CONSTRUCTION DOCUMENTS

FALCON MARKETPLACE

SF-19-001

75% SUBMITTAL 12-20-18

**SOUTH
ROUNDBOUT
PROFILES**

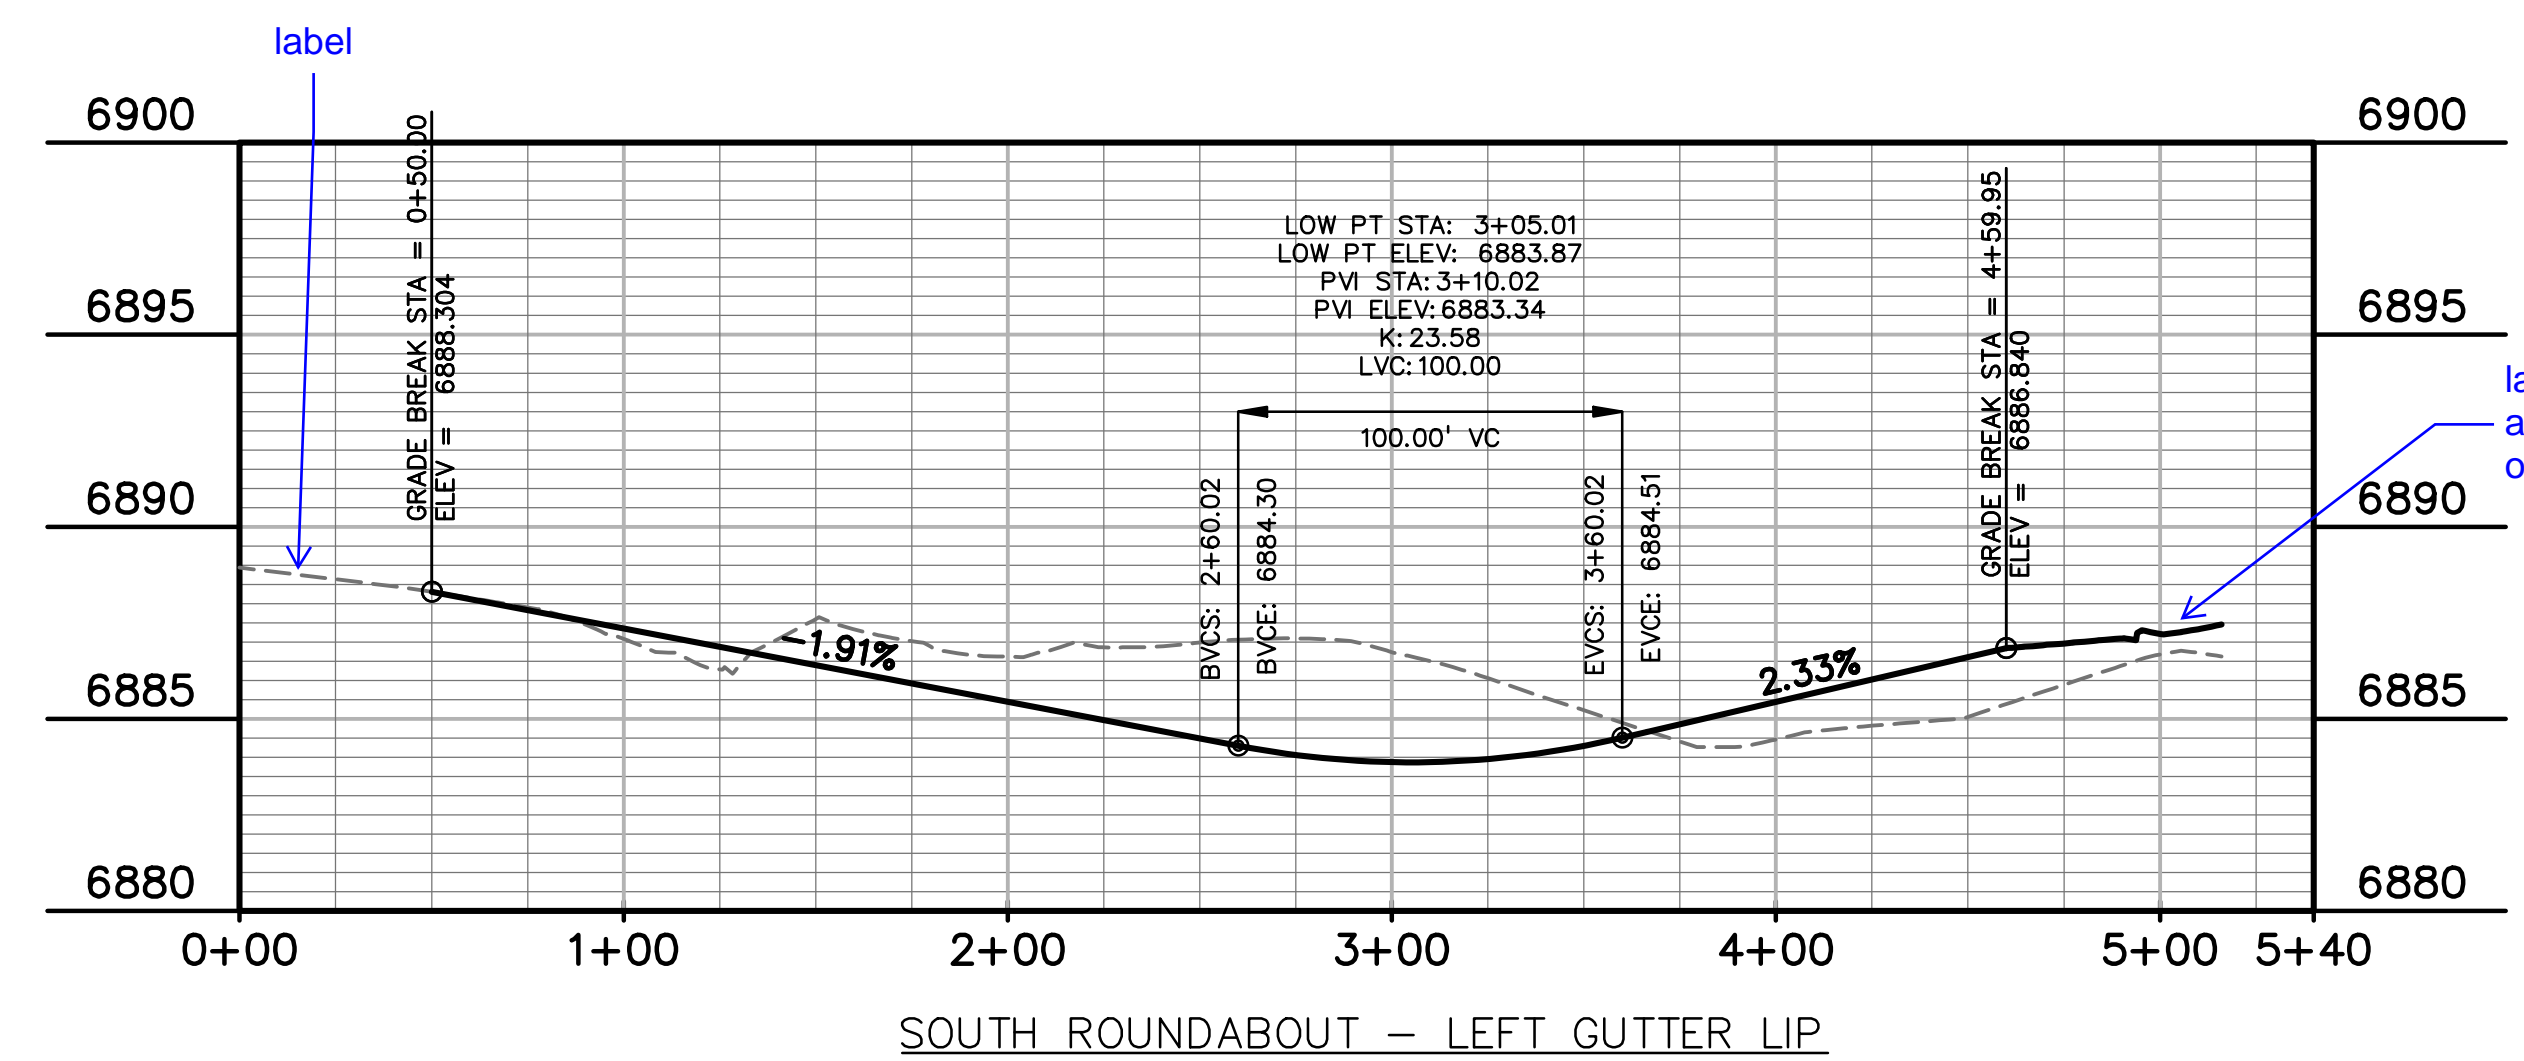
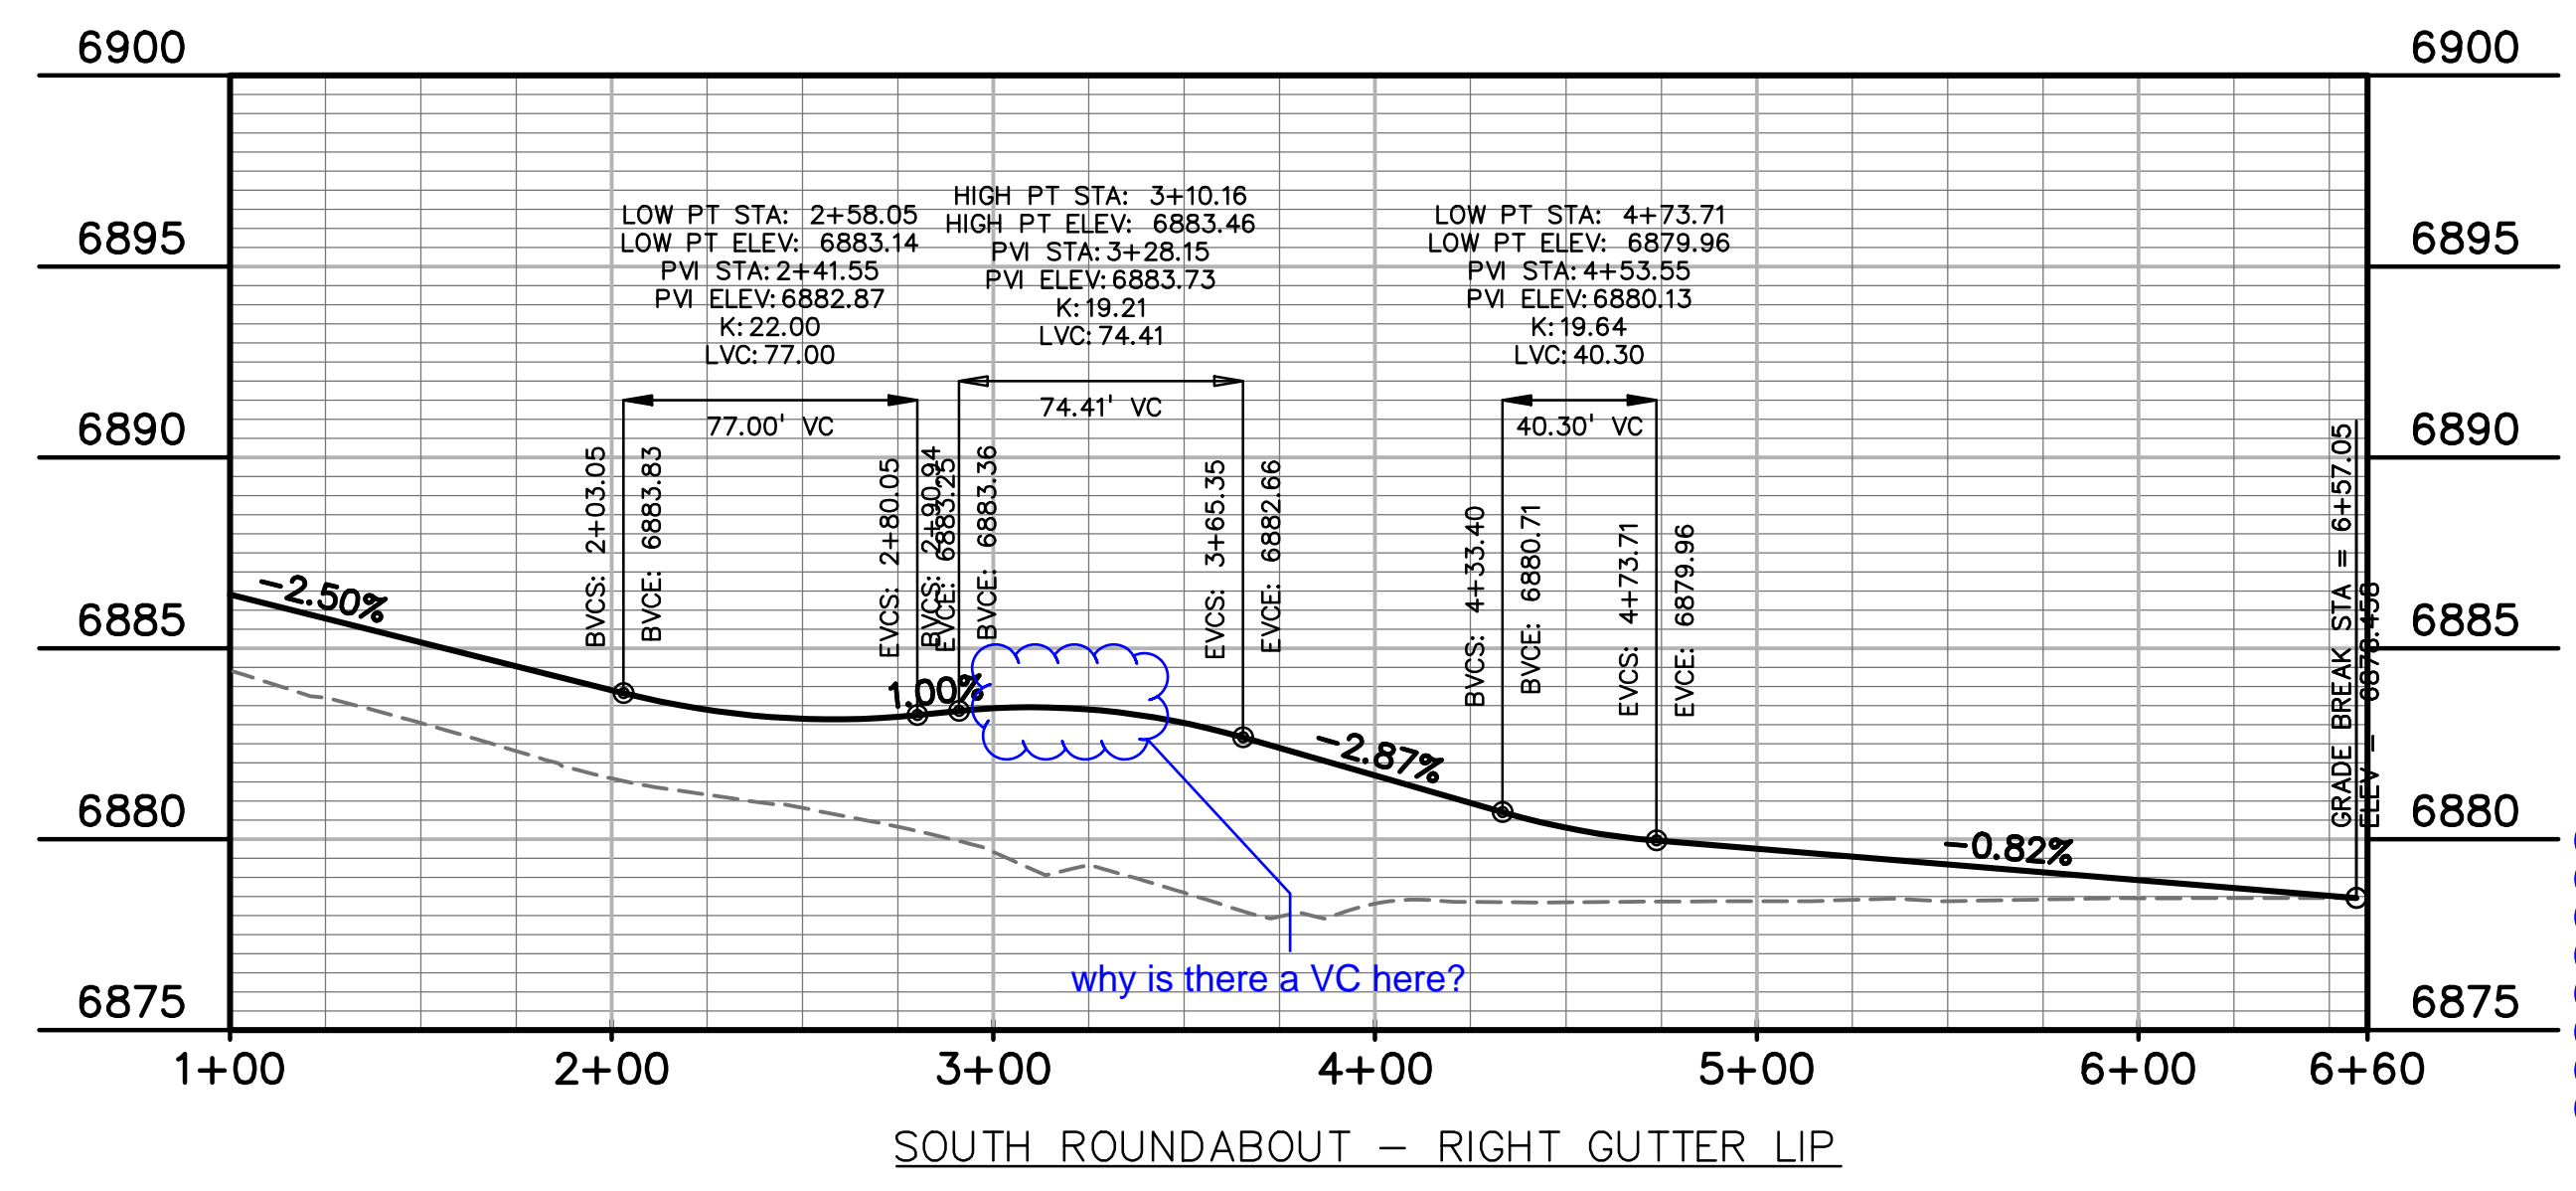
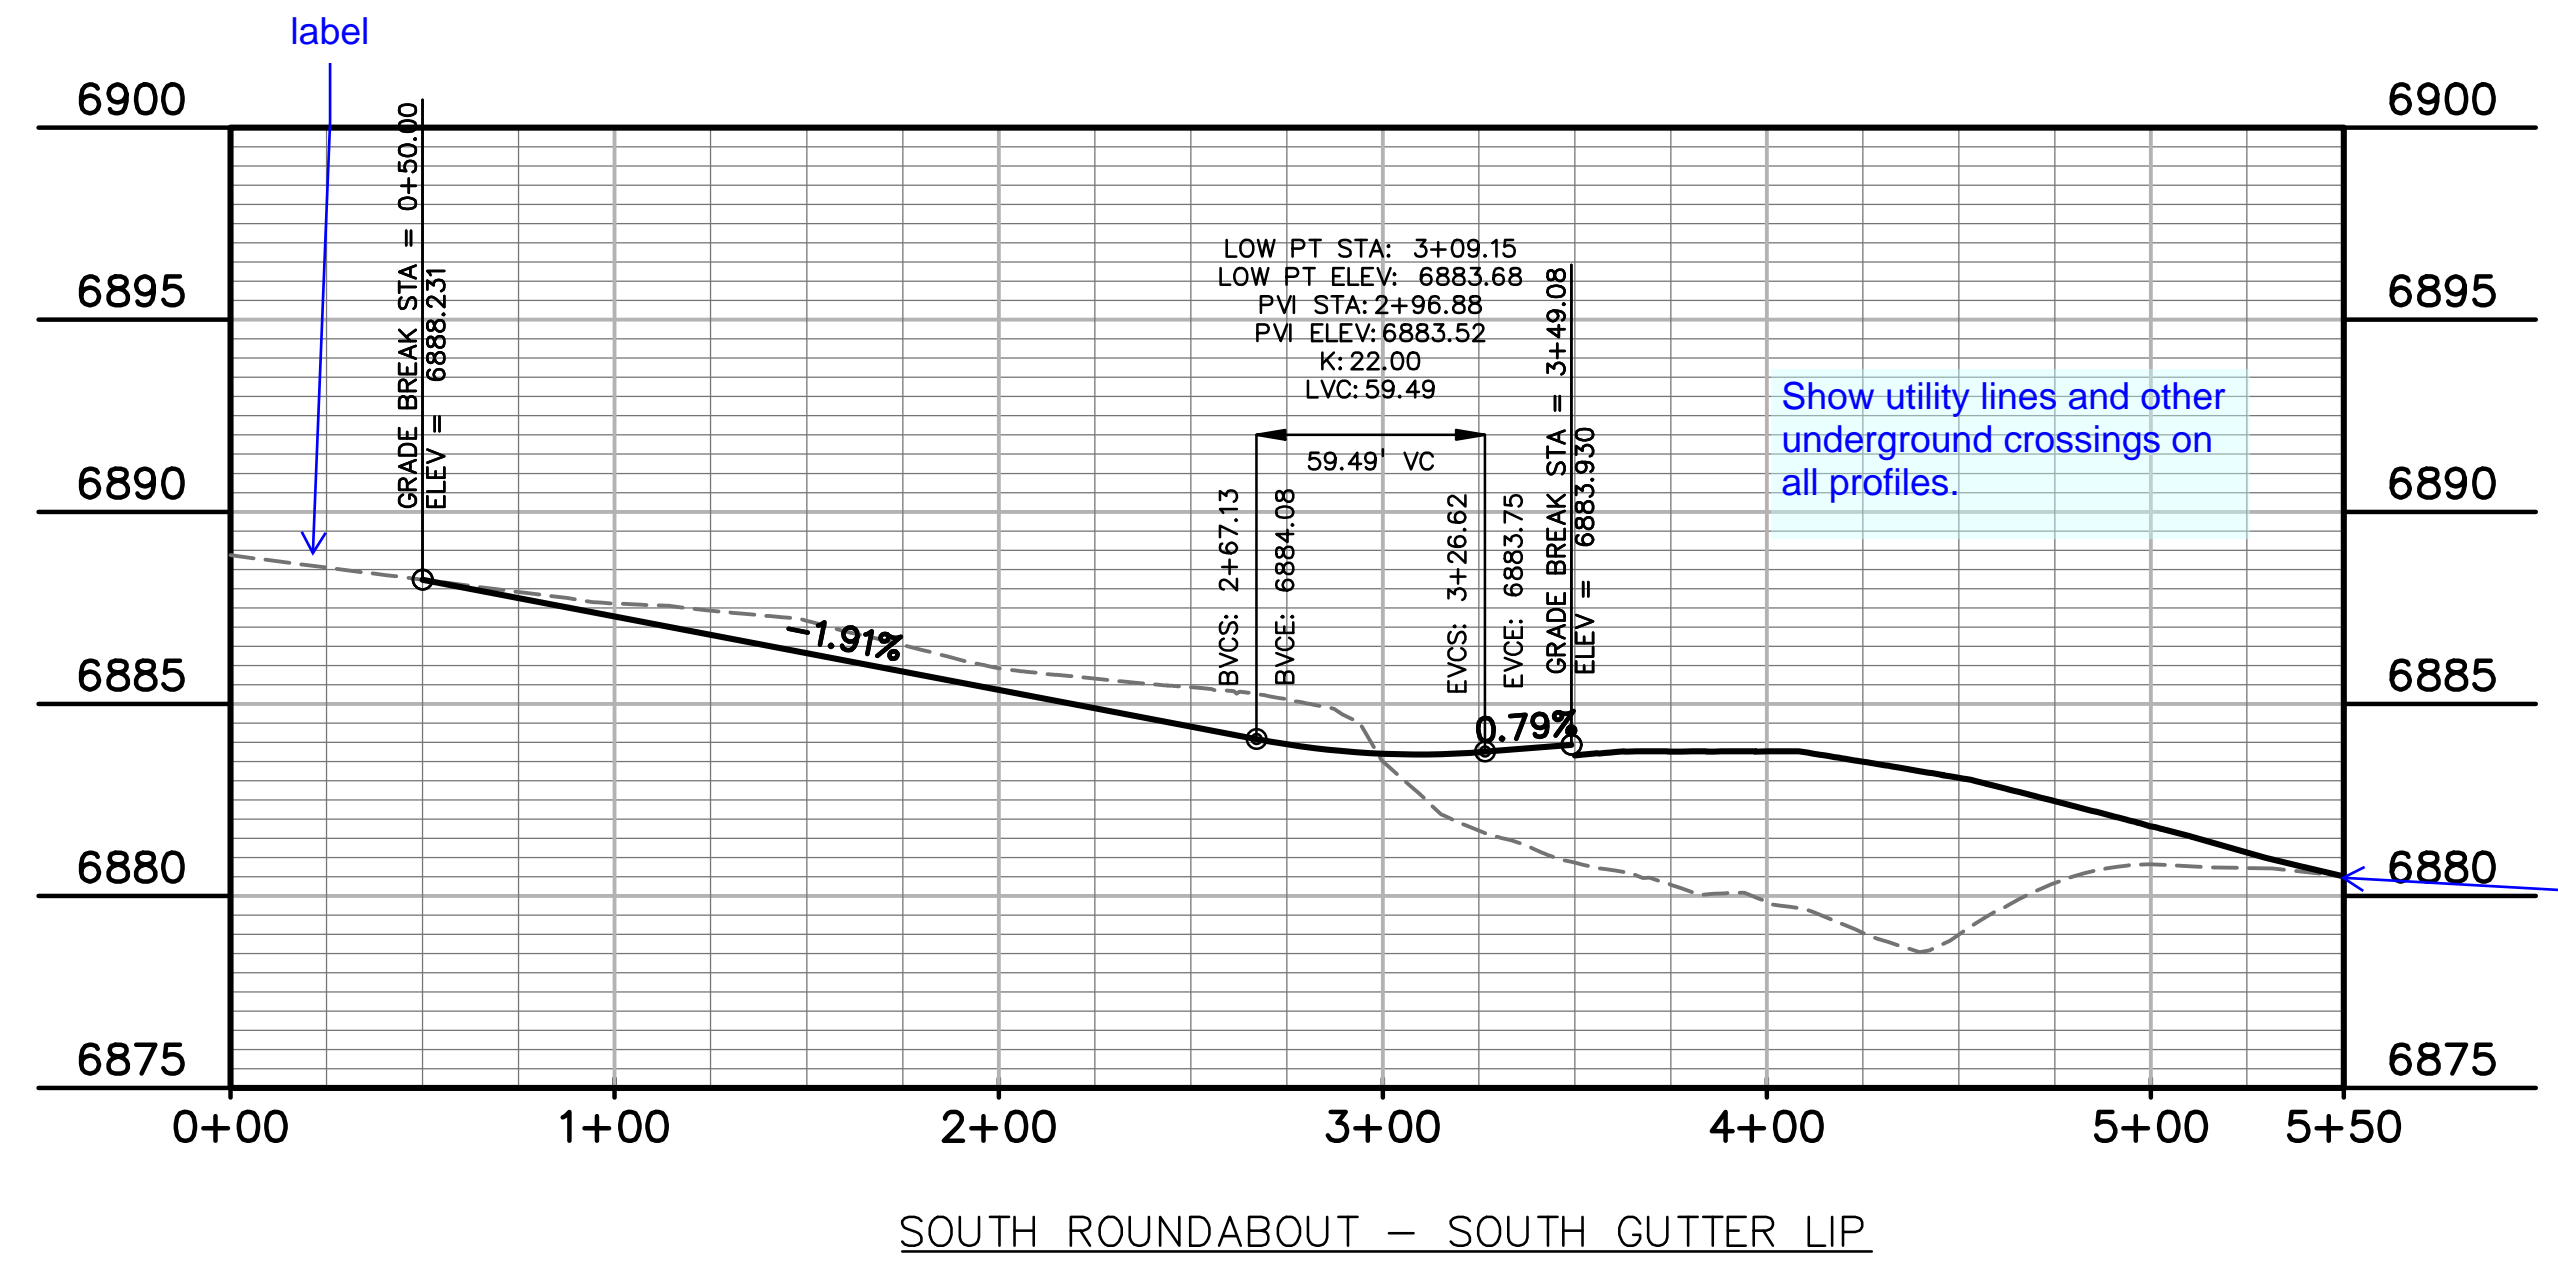
show ROW and property lines
label C&G types

Provide complete
details

Show utilities and easements.

Provide complete
details

label beginning and end stations on all profiles.

why is there a VC here?

Show utility lines and other underground crossings on all profiles.

show continuation of existing grades, with labels, or matchlines calling out continuing sheet on both ends of all profiles

show and label existing improvements

Provide alignment data, survey control.
Show utilities and easements.
